APPLICATION NO.	FILING DATE	FIRST NAMED INVENTOR	ATTORNEY DOCKET NO.	CONFIRMATION NO.	
09/729,743 12/06/2000		Steven B. Bridgers	P-5200-01-00	7935	
7	7590 06/11/2002				
Stephen R. Greiner, Esquire			EXAMINER		
GREINER LA 6701 Democra	W OFFICES, P.C.		FERGUSON, MICHAEL P		
Suite 110			ART UNIT	PAPER NUMBER	
Bethesda, MD	20817		3679	THE ENTIRE STATE OF THE STATE O	
			DATE MAILED: 06/11/2002

Application No.	Applicant(s)					
	09/729,743	BRIDGERS, STEVEN B.		u			
Office Action Summary	Examiner	Art Unit		1			
	Michael P. Ferguson	3679					
The MAILING DATE of this communication appears on the cover sheet with the correspondence address Period for Reply							
A SHORTENED STATUTORY PERIOD FOR REPLY IS SET TO EXPIRE 3 MONTH(S) FROM THE MAILING DATE OF THIS COMMUNICATION. - Extensions of time may be available under the provisions of 37 CFR 1.136(a). In no event, however, may a reply be timely filed after SIX (6) MONTHS from the mailing date of this communication. - If the period for reply specified above is less than thirty (30) days, a reply within the statutory minimum of thirty (30) days will be considered timely. - If NO period for reply is specified above, the maximum statutory per

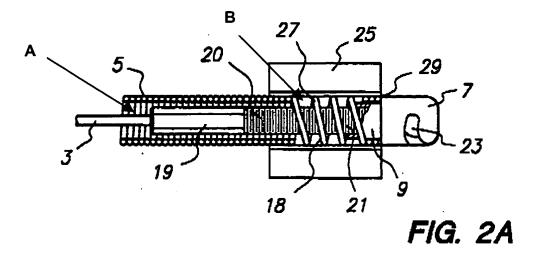
As to claim 5, McGaffigan discloses a connector system wherein spring members

18 are helically coiled springs (Figures 1A- 6).

As to claim 6, McGaffigan discloses a connector system wherein in helically coiled springs **18** are extension springs (Figures 1A- 6, column 6 lines 41- 68).

FIG. 3A

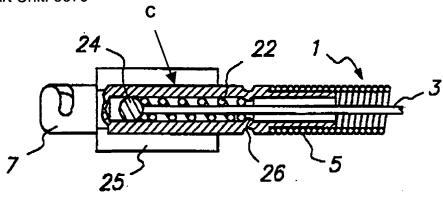
As to claim 15, McGaffigan discloses an internodal connector architecture system having:

a plurality of nodal body members 25, 33, each of the body members having a plurality of compliant strut members 1 attached thereto, each strut member including a spring member 22 adjacent the nodal member and an elongated hollow link member C, 5 connected to a link member C on an adjacent nodal member (Figure 3A).
